Addendum #1-

Date of Issuance: Monday, September 21, 2026
Project **Enhanced Endodontics – Panama City Beach, FL**

Responses below by John Bozarth or Antonio Reeves, unless noted otherwise.

NEW MECHANICAL POWER PLAN

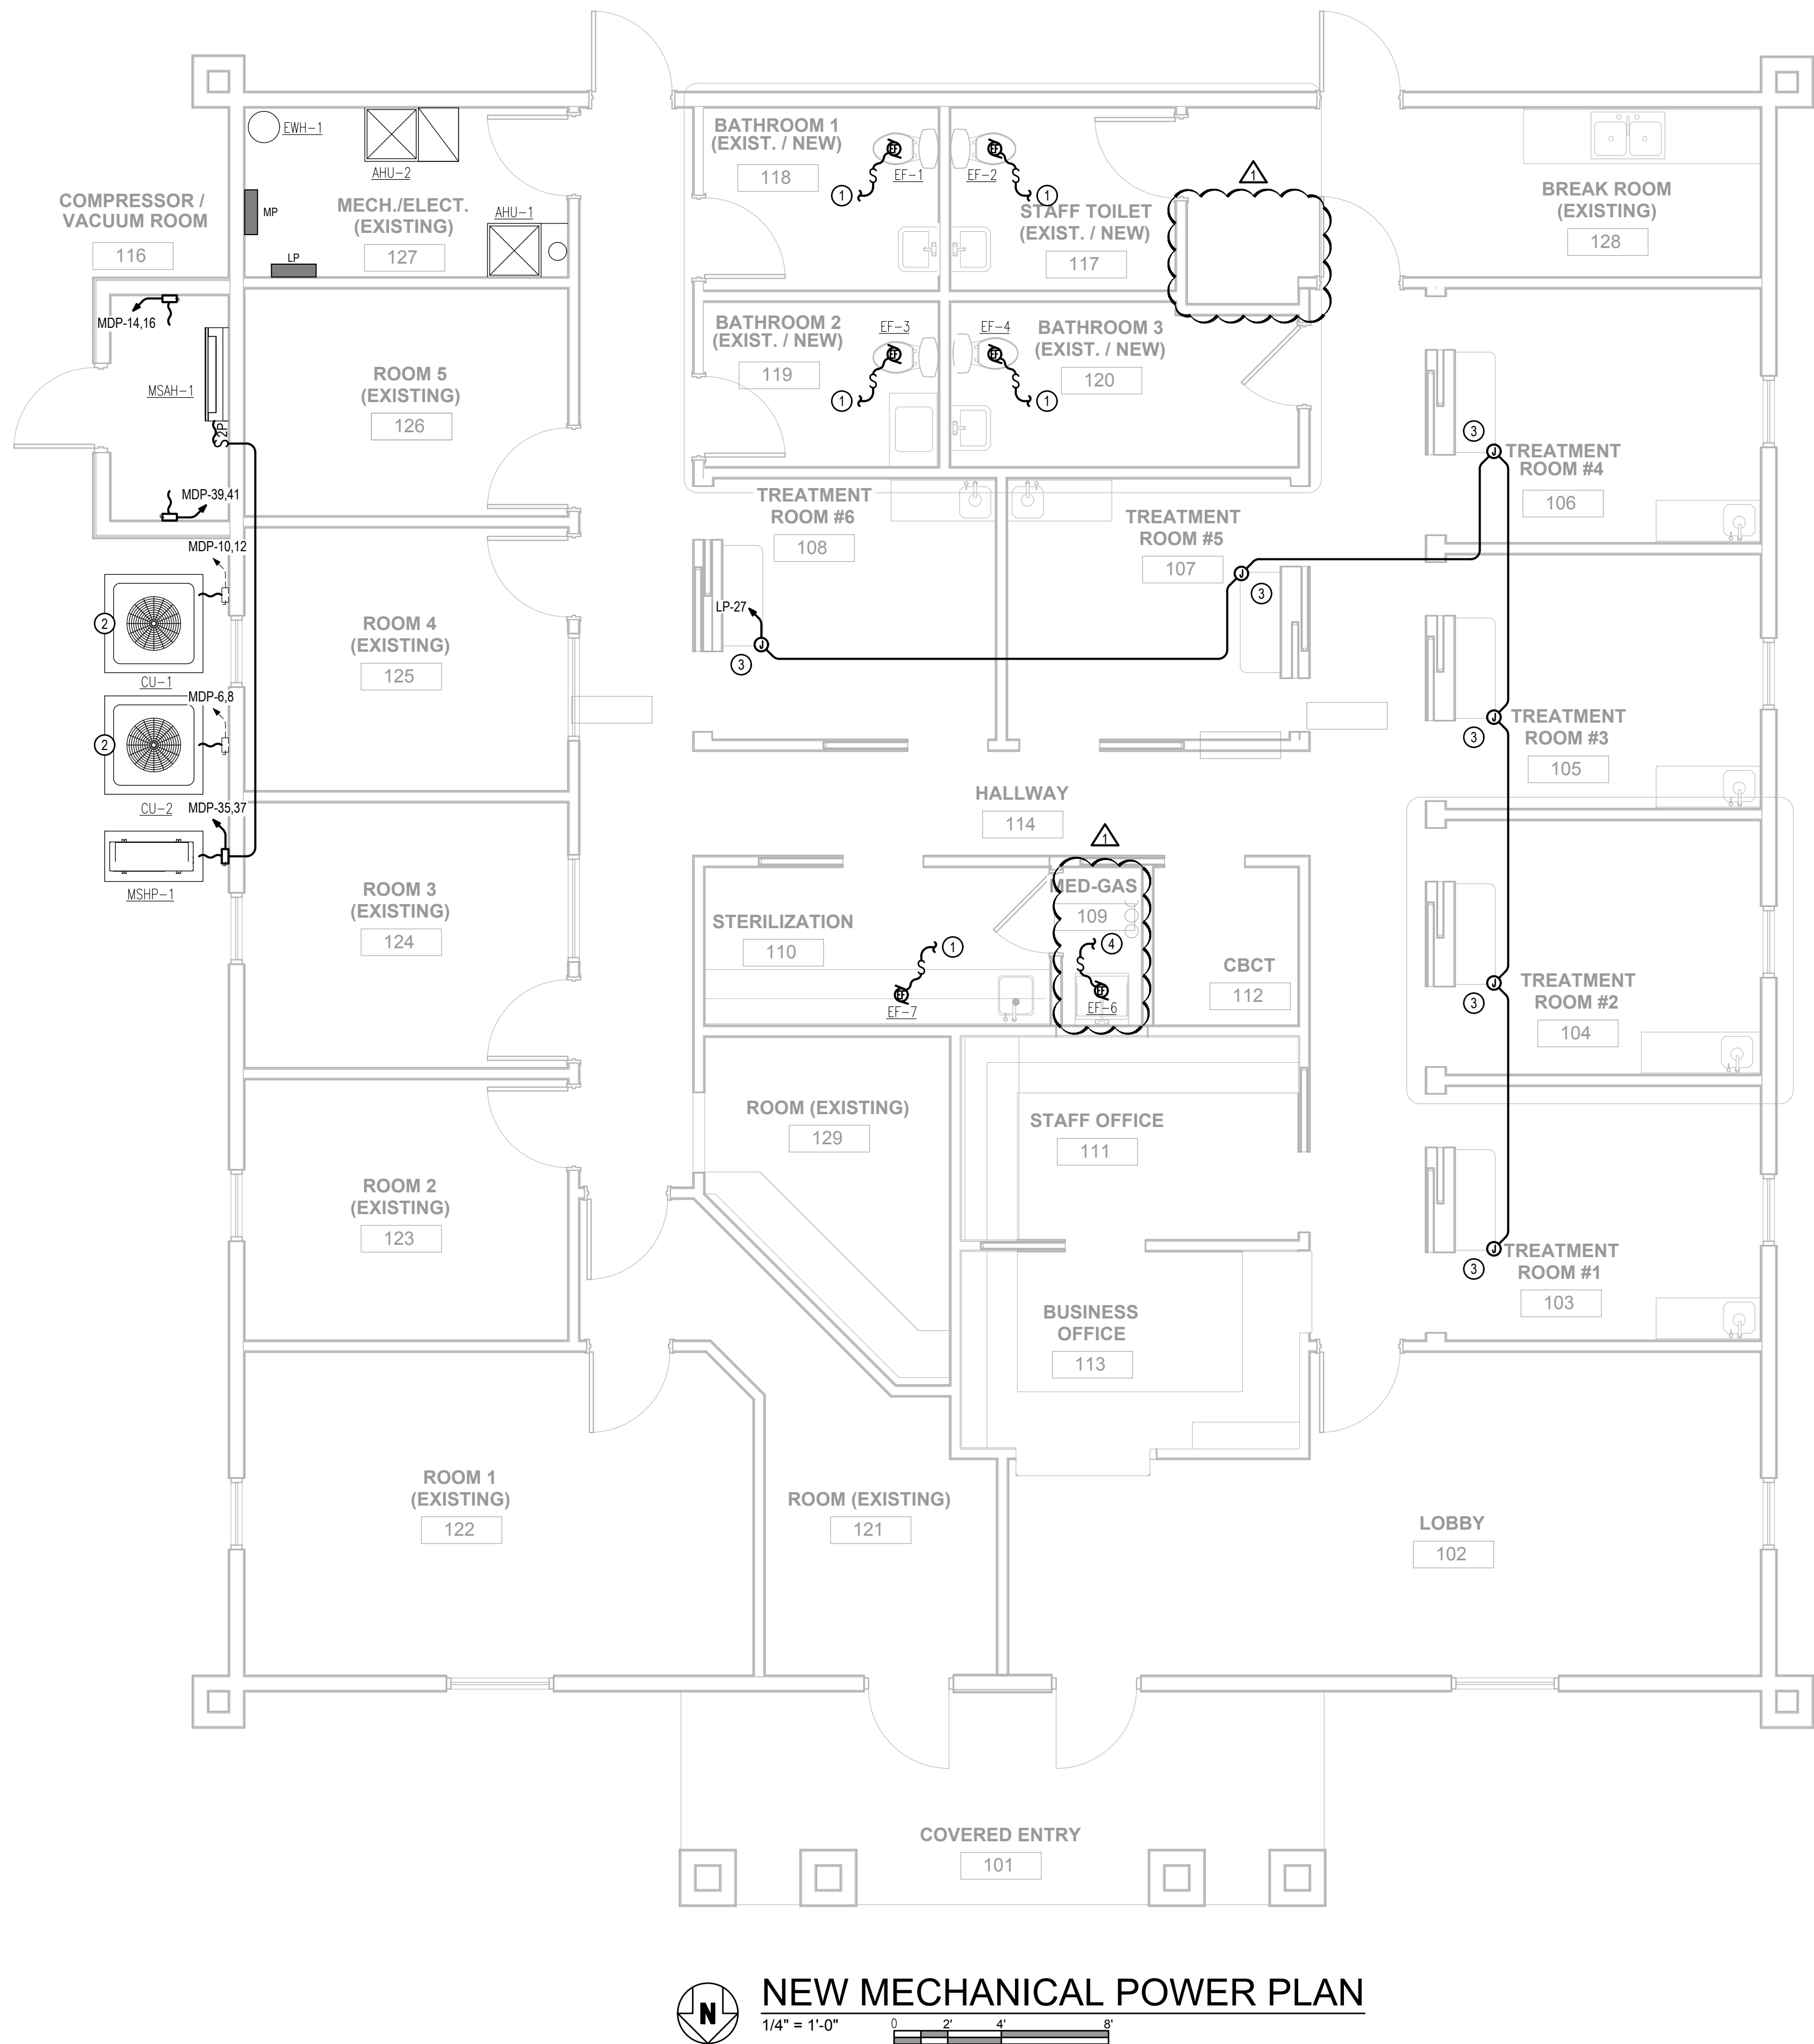
9. Sheet E-112 – NEW MECHANICAL POWER PLAN
 - h. Deleted Janitor's Closet and Exhaust Fan #5.
 - i. Exhaust Fan #6 to be tied into local lighting circuit for power, keynote 4.

T-111

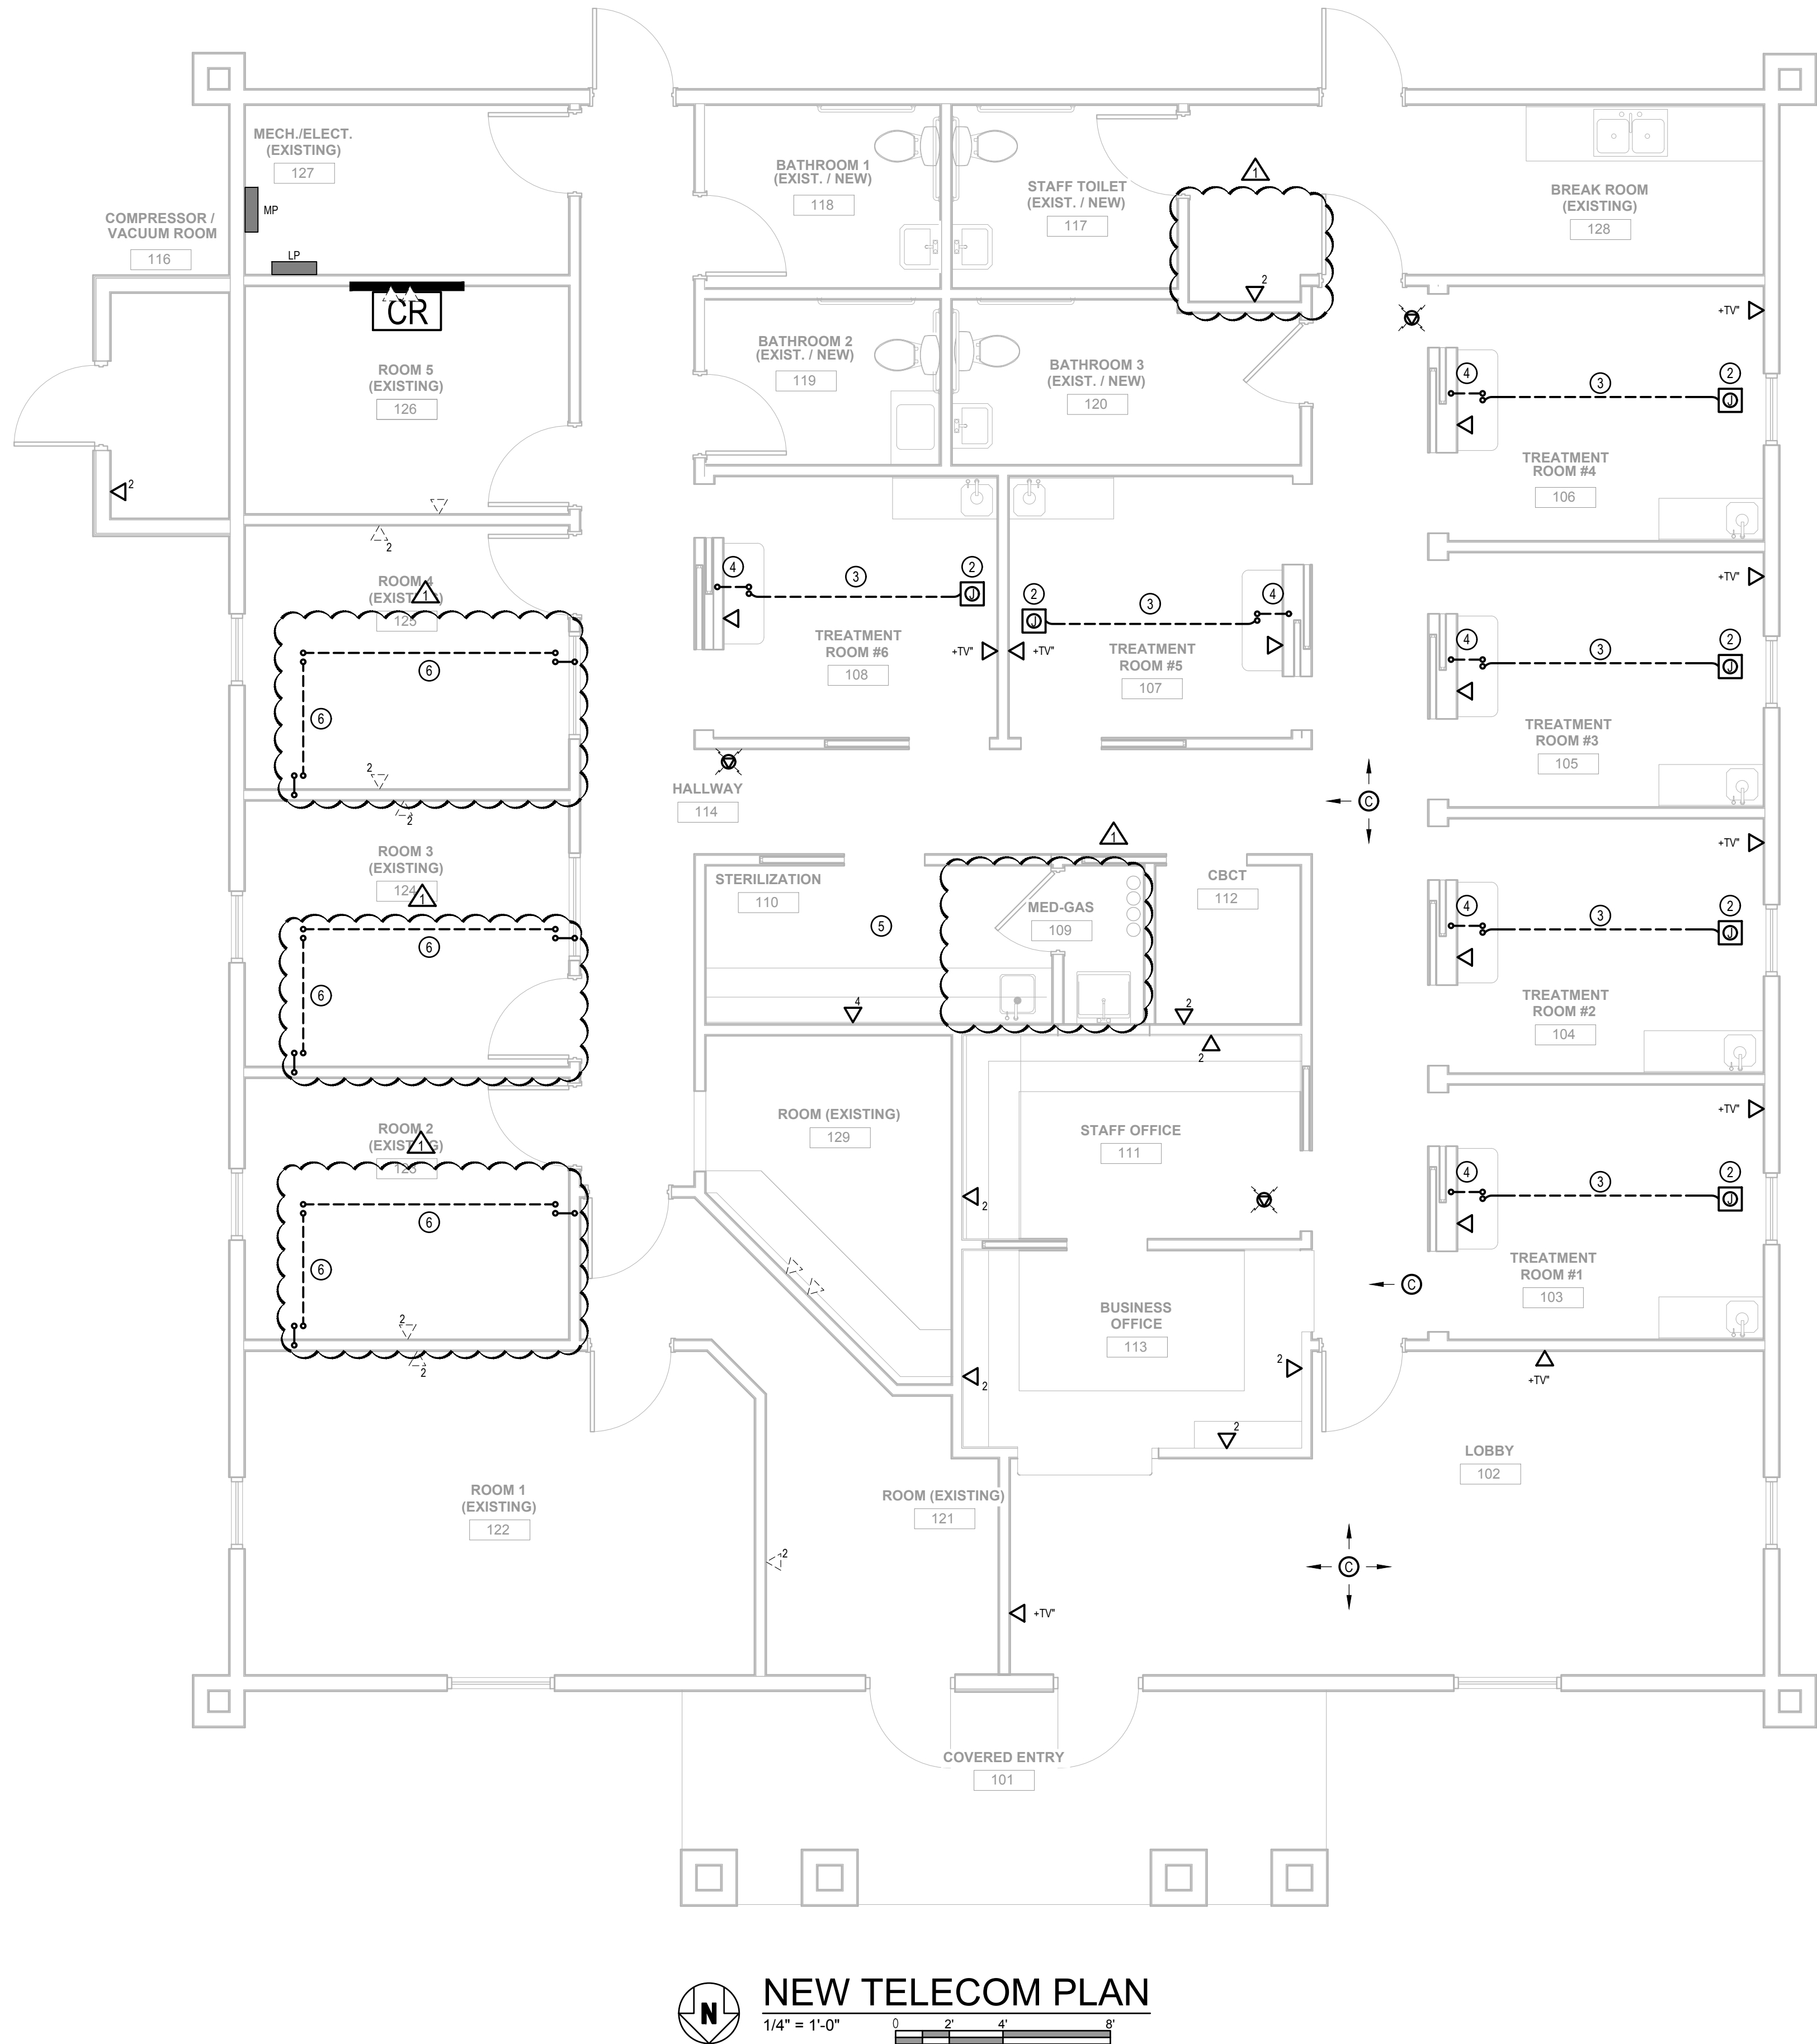
- p. Deleted Exhaust Fan #5, updated all other Exhaust Fans and Vacuum Pump in Mechanical Coordination Schedule.
- 13. Sheet T-111 – NEW TELECOM PLAN
 - q. Deleted Janitor's Closet, added data for expected computer.
 - r. In Med-Gas room, Manifold and Security systems moved from Telecom sheet to Power sheet.
 - s. In rooms 123-125, added future use conduits and keynote 6 to go with it.
- 14. Sheet T-601 – TELECOM SCHEDULES
 - t. Revised Patch Panel schedules to accommodate new computer data outlet.

A1.1

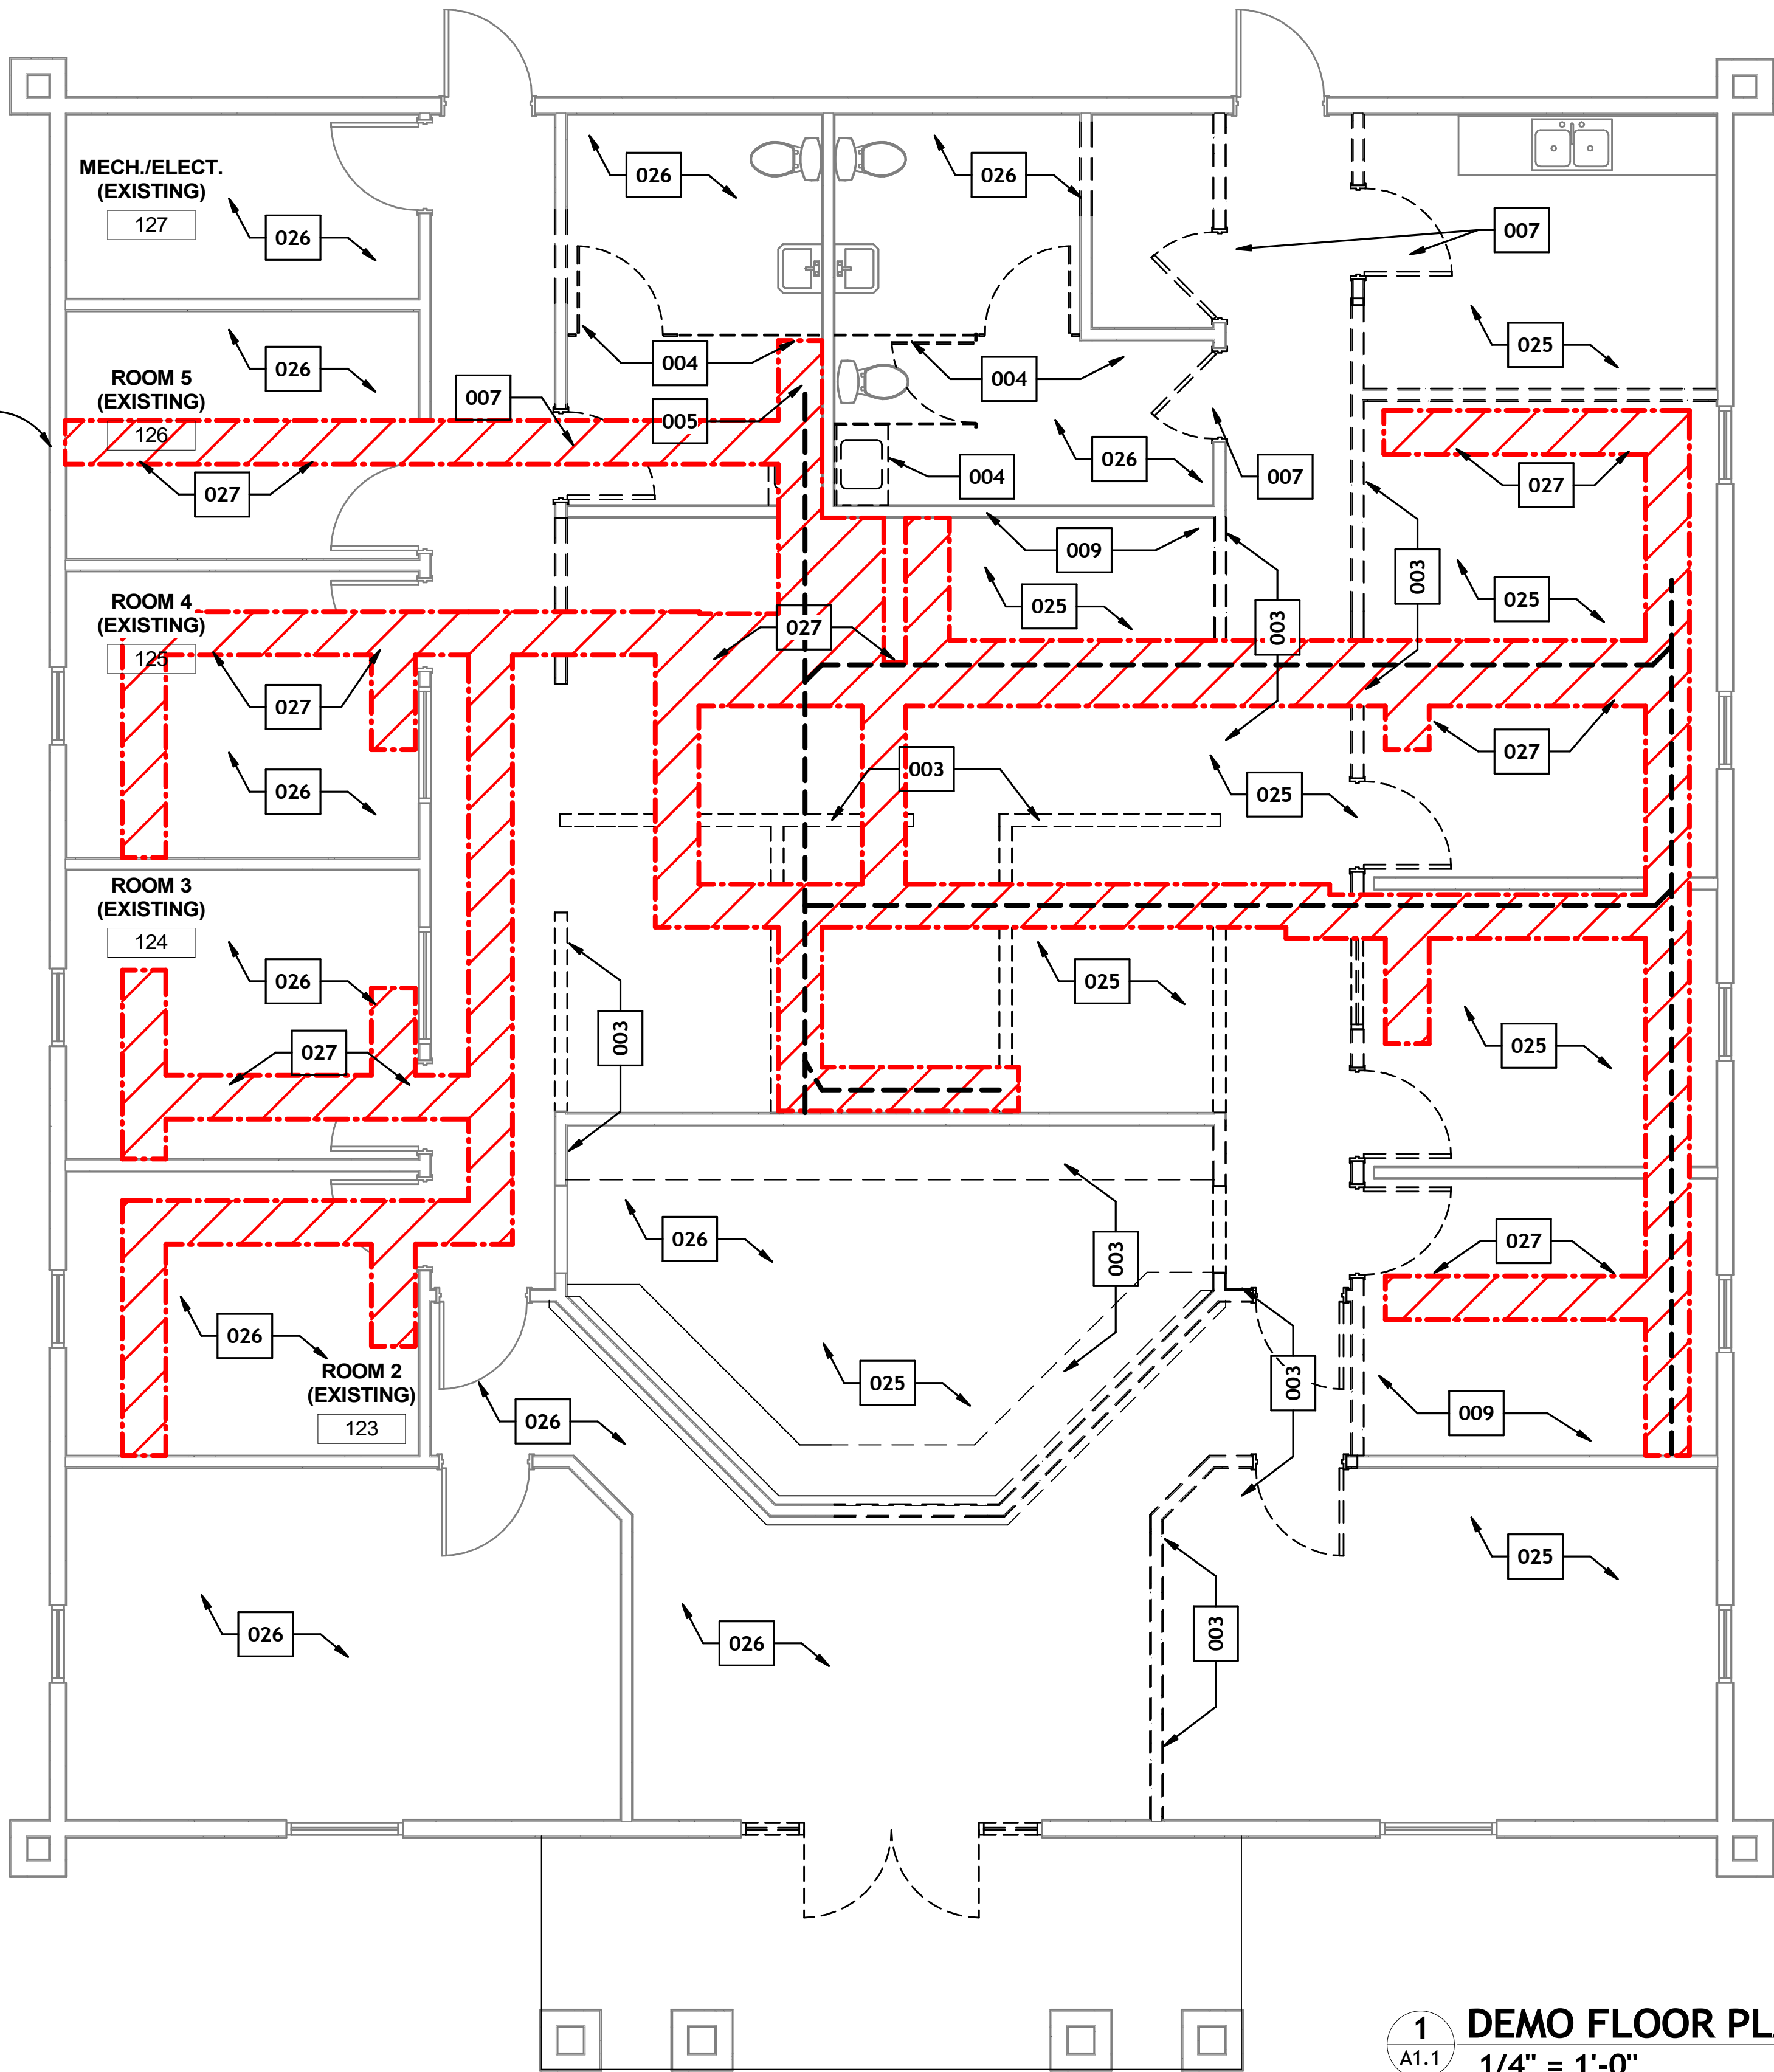
1. Sheet A1.1 – DEMO PLAN
 - a. Added Demo Legend. Revised concrete demo layout.
 - b. Deleted door and walls at original Janitor's closet location.
 - c. Removed ceiling at original Janitor's closet location.
